COUNTY OF FLUVANNA, VIRGINIA
(IFB) #2021-01
FLUVANNA COUNTY – BASEMENT RENOVATION

ADDENDUM # 2:

ADDENDUM NO. 2

Fluvanna County
Multipurpose Room Additions and Renovations
CRA Project No. 3430

MECHANICAL SCHEDULES, DETAILS, AND CONTROLS

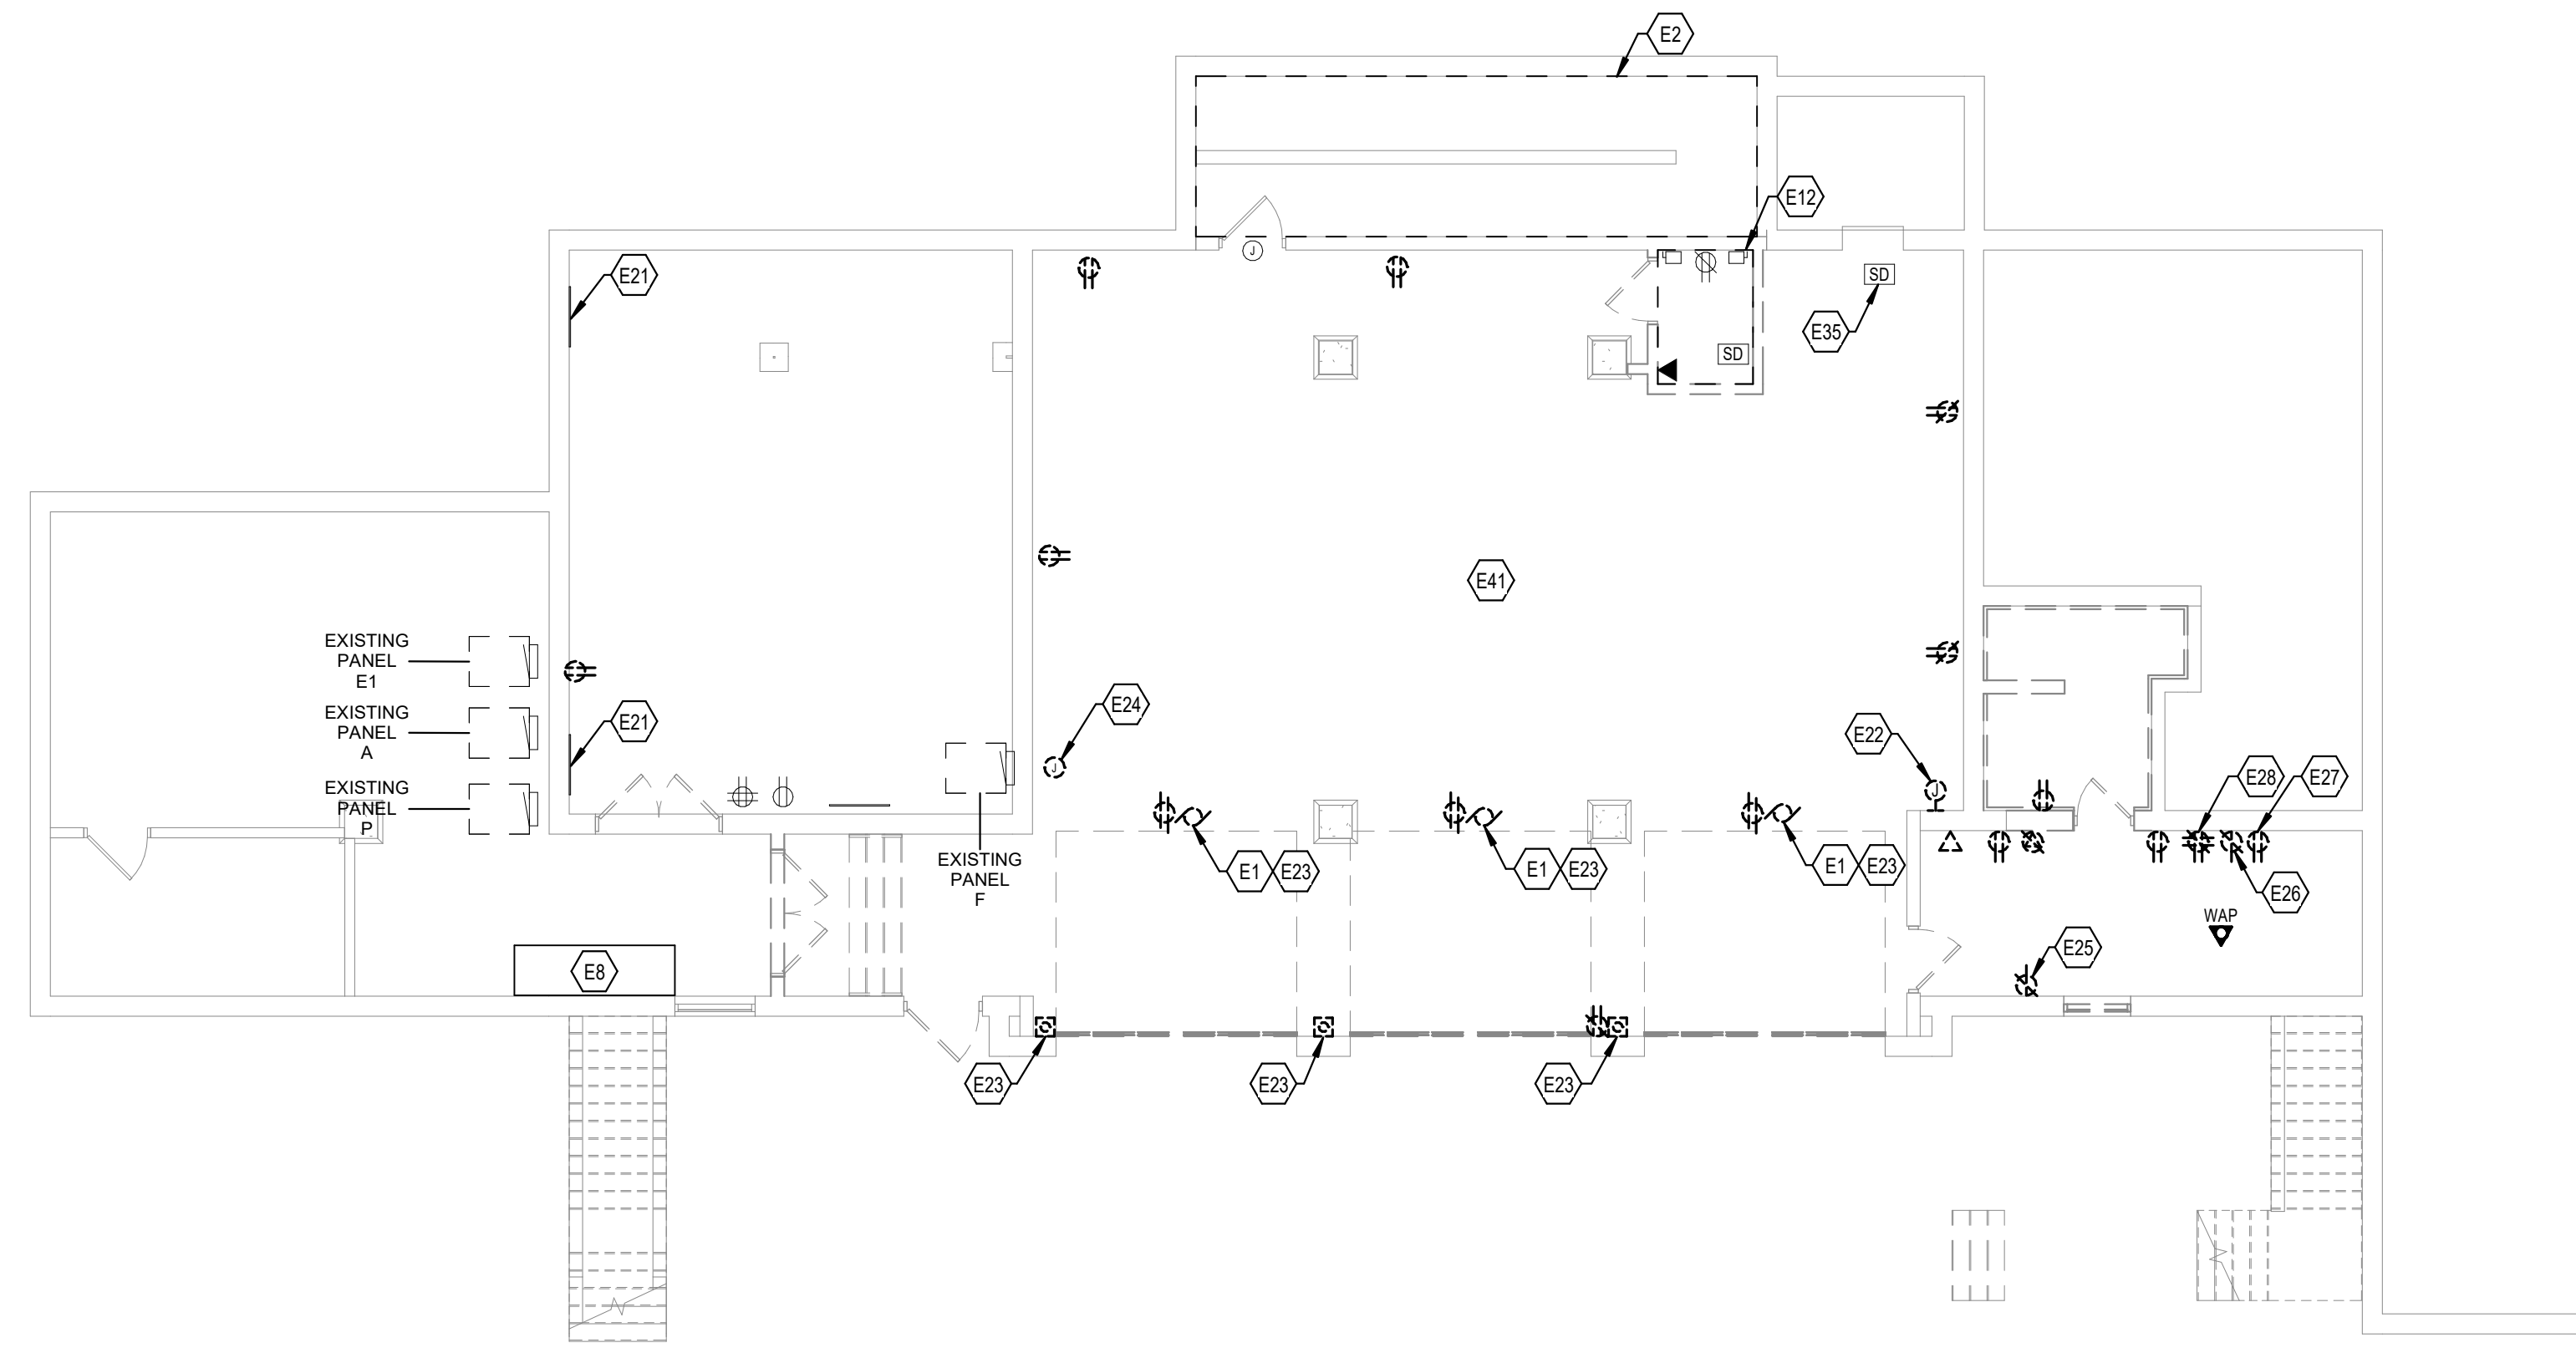
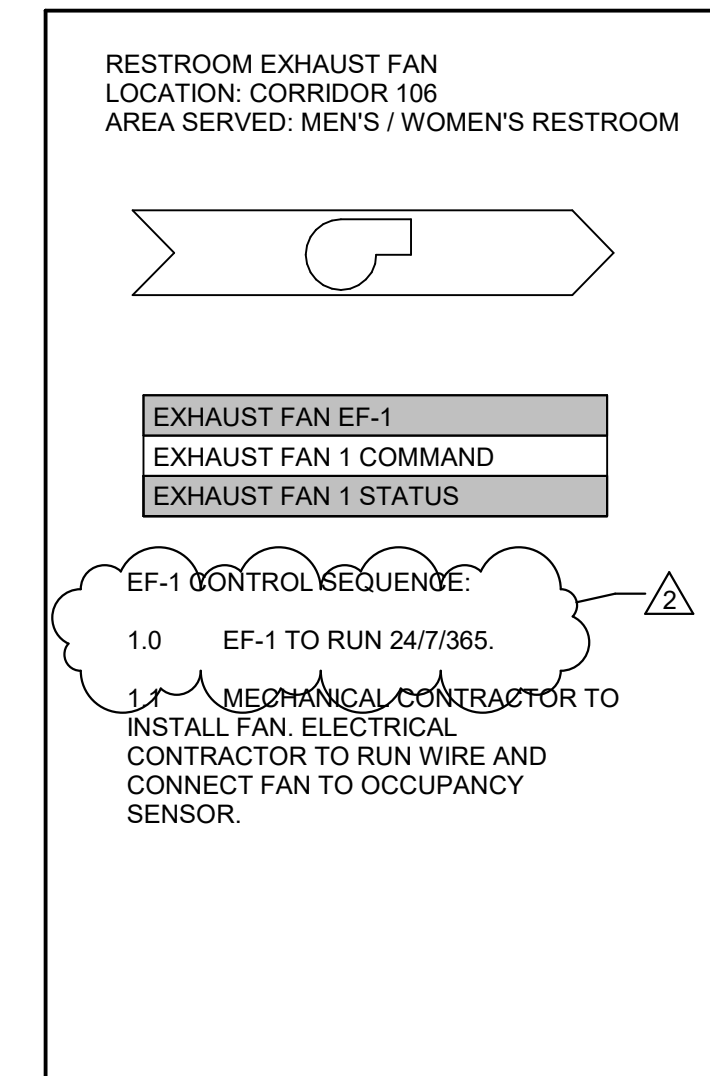
1. REPLACE this sheet in its entirety with the attached sheet.
 - a. Updated EF-1 to add machine room exhaust.
 - b. Updated EF-1 Control Sequence.
 - c. Updated velocity on L-1.

2 POWER/SYSTEMS NEW WORK PLAN
SCALE: 1/8" = 1'-0"
0 2' 4' 8' 16' 24' 32'

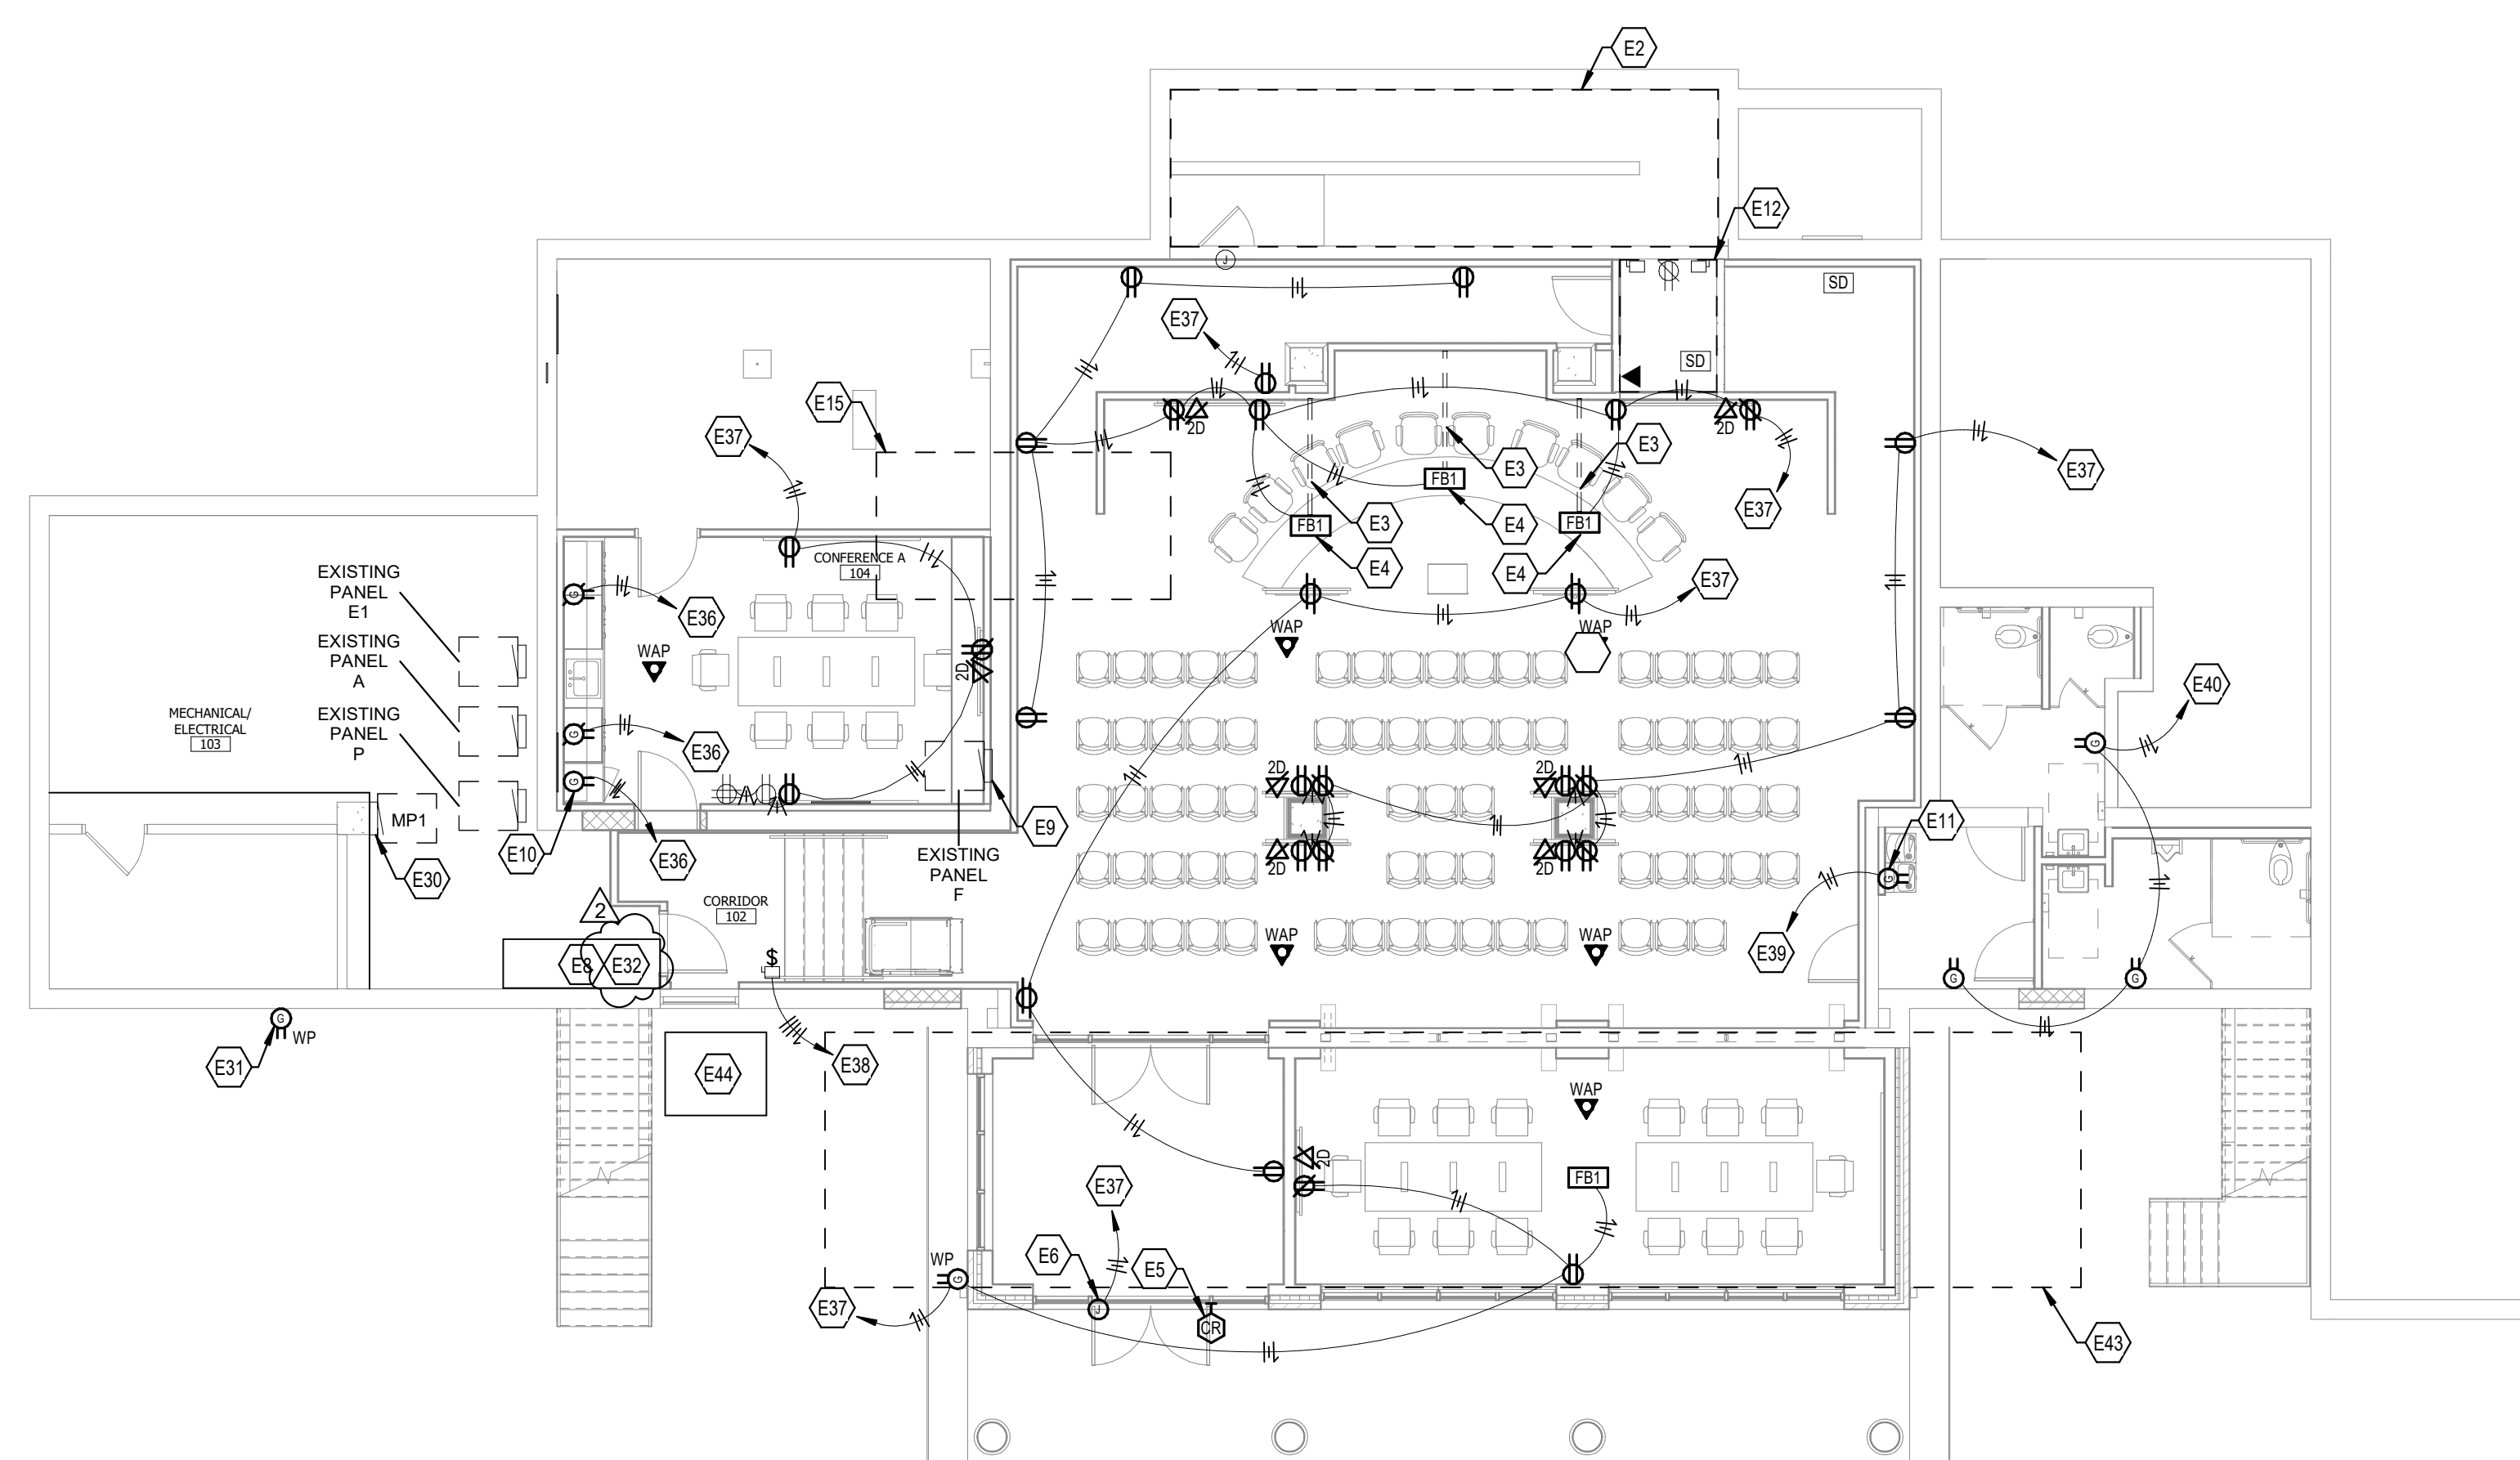
1. REPLACE this sheet in its entirety with the attached sheet.
 - a. Updated tagged note E43 to read "EXISTING ELECTRICAL LINES LOCATED UNDER NEW ADDITION BASED ON SURVEY. OWNER TO CONTACT AND PAY DOMINION DIRECT FOR ALL WORK ASSOCIATED WITH RELOCATING THESE LINES OUTSIDE OF NEW ADDITION FOOTPRINT."
 - b. Added note H under 'Electrical Power Notes' to read "WHERE NEW RECEPTACLES ARE SHOWN, PROVIDE IN NEW STEEL STUD FRAMED WALLS. FOR ANY LOCATION BEING EXTENDED FROM EXISTING CMU, PROVIDE EXTENSION RINGS AND EXTEND TO NEW FACE OF WALL."
 - c. For clarification there are no new fire alarm devices. The existing building does not have a fire alarm system. No new fire alarm devices will be installed.
 - d. For clarification, tagged note E32 that is on E-201 will be added to E-200 for panel MP1 feeder connection.
